From: Pfeiffer, Jane K - DNR
Sent: Monday, September 12, 2022 1:01 PM
To: Robert Reineke
Cc: Pratap Singh
Subject: RE: CWC- West Block (02-41-587376) VMS Commissioning Info Request

PROJECT TITLE: SITE INVESTIGATION REPORT
3212 W. CENTER ST., 2727 N. 32ND ST., 2758 N. 33RD ST.
COMMUNITY WITHIN THE CORRIDOR - WEST BLOCK
MILWAUKEE, WI 53210
PROJECT NUMBER: 40443

SHEET TITLE: Sub-slab Depressurization Location and Results

FIGURE 1

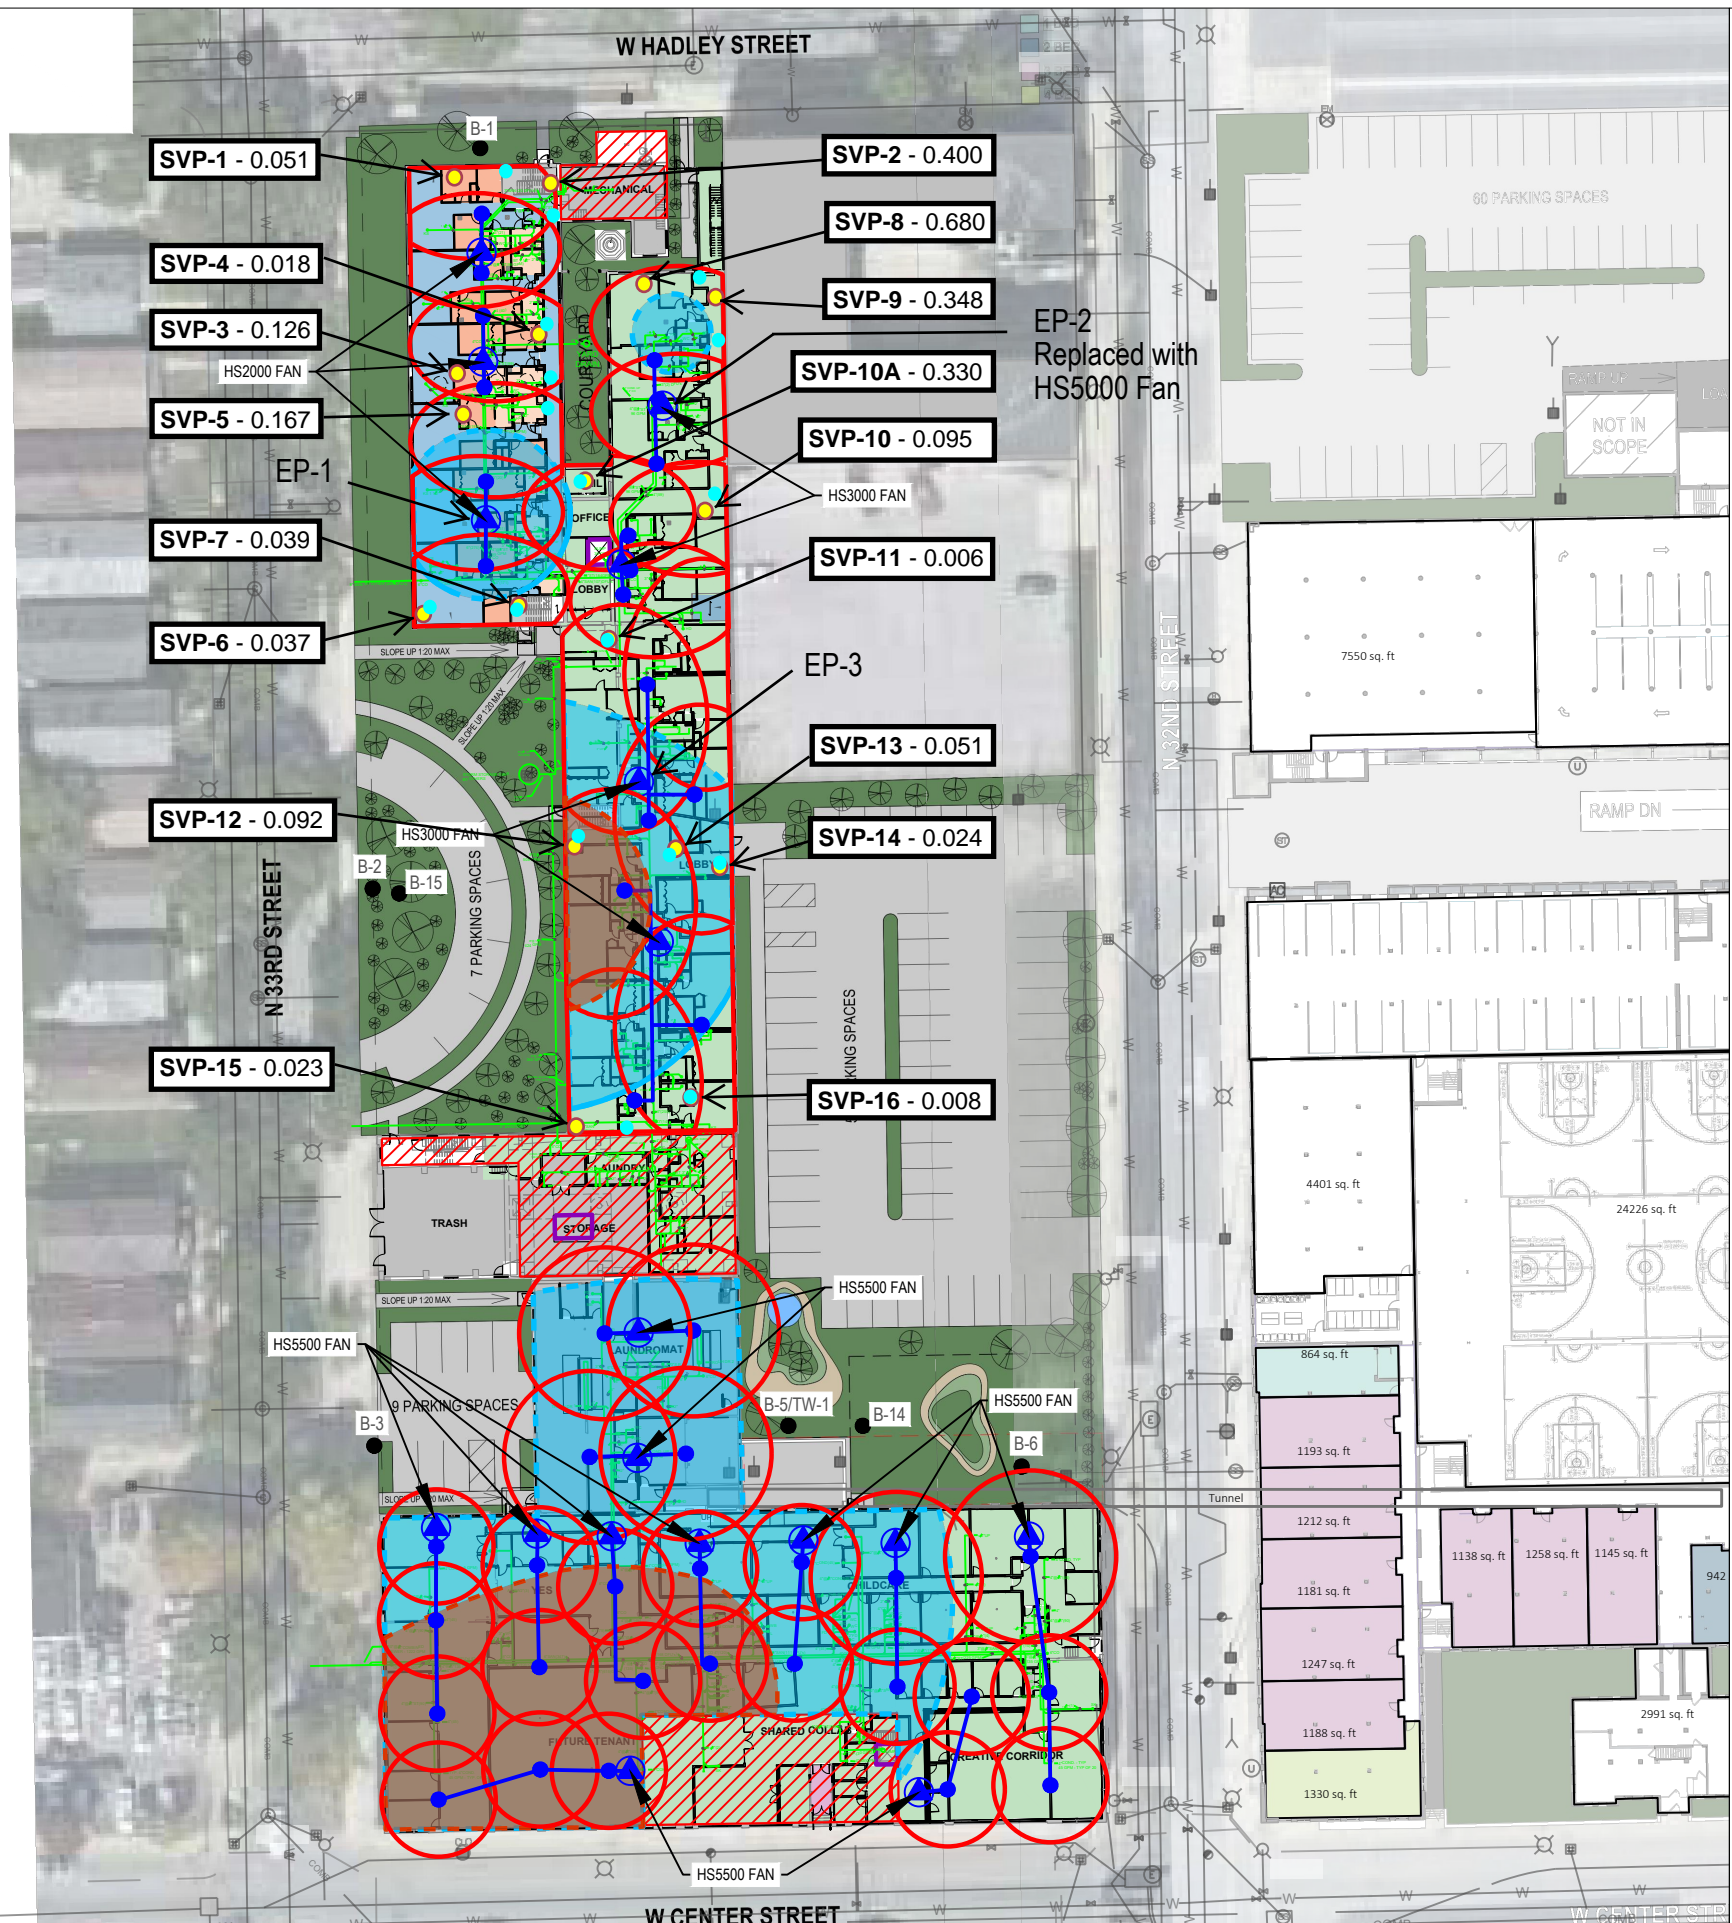
I think I found a map showing the fan locations – Please confirm that the “exterior fan locations” shown on the attached figure are correct and that these are the locations where the exhaust samples were collected.

Can you please provide me with an update on the first round of commissioning for Buildings 4 and 5 for the above-referenced site? Has the commissioning occurred yet and, if so, when will the results be submitted to the DNR? Additionally, please present a figure that displays the locations of all of the fans (i.e., the exhaust sample locations) on the rooftops of Buildings 6, 7, 8A, and 8B.

Please find attached an amended plan which has the same number of subslab vapor measurement points.
